Review of Menthon et al. "Comparison of calibration methods of a PICO basal ice shelf melt module implemented in the GRISLI v2.0 ice sheet model"

Reviewer: Xylar Asay-Davis

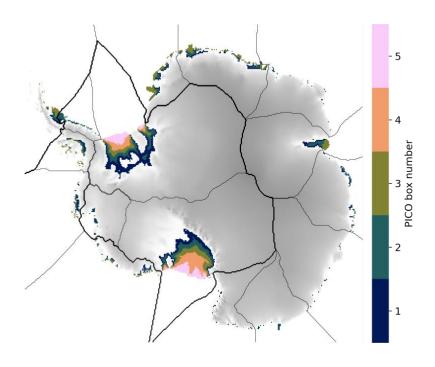
l. 83: "we decide to make use of the drainage basins defined in (Mouginot and Rignot, 2017) and used in (Rignot et al., 2019)": Please change "make use of" to something more specific. It seems that you treat all ice shelves in each basin as if they were a single ice shelf in PICO.

We changed this to: "To reduce computational costs we avoid identifying individual ice shelves in each time step, instead we decide to solve one instance of the PICO equations per drainage basin, with the basins as presented in Mouginot and Rignot (2017) and used in Rignot et al. (2019), ..."

This is indeed the case, all ice shelves in one drainage basin are seen as one even though they might be physically separated. To clarify, we added the following at the end of the paragraph:

"This simplification of solving one PICO instance per drainage basin enables us to compute faster for each ice shelves their number of boxes, as well as their corresponding temperature and salinity inputs."

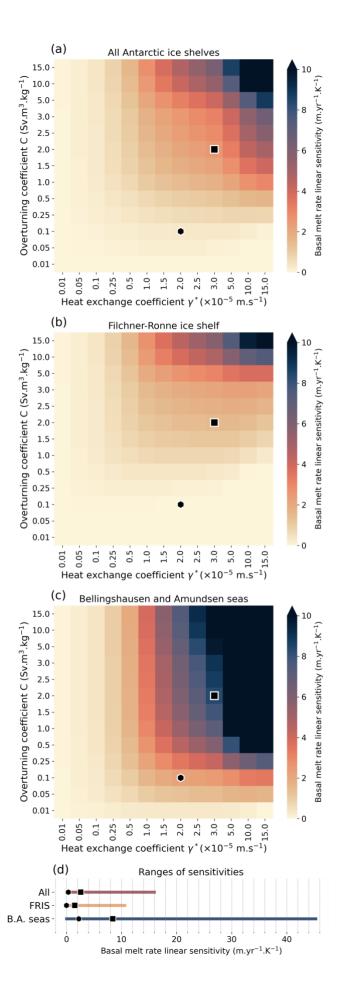
l. 360-362: I really like the point about sensitivity to oceanic forcing in QuadNL. But I take issue with "therefore this QuadNL calibration could overestimate basal melt rates". I don't think this follows. The lack of refreezing certainly will mean that, if the method is calibrated to get the right mean melt, it will also underestimate melt maxima. But it doesn't follow that it will overestimate melt on the whole, this depends on the detail of the calibration approach. I would remove this phrase.

Thank you for pointing this out. We agree and remove this bullet point. We would like to bring attention to the new bullet point that discusses sensitivity in differently, it reads as follows:

"The sensitivity to ocean warming in our calibrated version of PICO lies below some previously reported ranges of Antarctic ice shelf sensitivity \citep{Levermann2020-esd, VanderLinden2023-tc}, and is more consistent with the PICO sensitivity range estimated by \citet{Lambert2024-tc}. In their study, the PICO sensitivity is lower than that obtained with other sub-shelf melt rate parameterisations, although it is not the lowest overall. By contrast, the QuadNL parametrisation lies on the higher end of sensitivity spectrum compared to other parametrisations \citep{Burgard2022-tc, Lambert2024-tc}. So far, neither PICO nor QuadNL sensitivities ranges, which also depend on their calibration, can be ruled-out as we do not know what the right sensitivity is."

This point is related to the new part 3.5 and new figure 8 that we show here (needed to response to the other reviewer's comments):

"Thanks to the ensembles with + 0 K and + 1 K ocean forcings from the previous subsection we can determine the sensitivity of PICO for all the ensemble members. We are here assuming a linear sensitivity and therefore compute it as the difference between the + 1 K experiment minus the + 0 K experiment. The results are shown in Figure 8 where we also differentiate the sensitivity in the 3 areas defined for the analysis shown in subsection 3.2. First of all, we see that in most cases the sensitivity of PICO increases when the value of either of the two parameters is increased. Second, we see that the sensitivity varies between areas. For instance, 1 K of warming with the calibration from PISM-PICO (squares

on the Figure 8) would lead to an increase of 1.5 m.yr-1.K-1 in Filchner-Ronne ice shelf, whereas it would be 8.4 m.yr-1.K-1 in the Bellingshausen and Amundsen seas ice shelves. We also see that the range of possible sensitivities (panel (d)) is about four times larger in the B.A. seas than in the FRIS. These results quantify how much the sensitivity of the basal melt rate would change, globally and regionally, by changing the values of the two PICO parameters. In all the cases, the best calibration with the MAE of bins (black hexagons) is in the low range of all the tested combinations of parameter values. These values are also lower than the range of Antarctic ice shelves sensitivity estimates from some previous studies (Levermann et al., 2020; van der Linden et al., 2023), but closer to the PICO sensitivity obtained by Reese et al. 2023; Lambert and Burgard (2024) when optimising parameters for present-day melting. The methodologies in the assessments of the sensitivities are however different in each study. Nonetheless, based on the results show in Figure 8 we can expect a low to moderate response of ice shelves in this calibrated version of PICO to future projections scenarios."
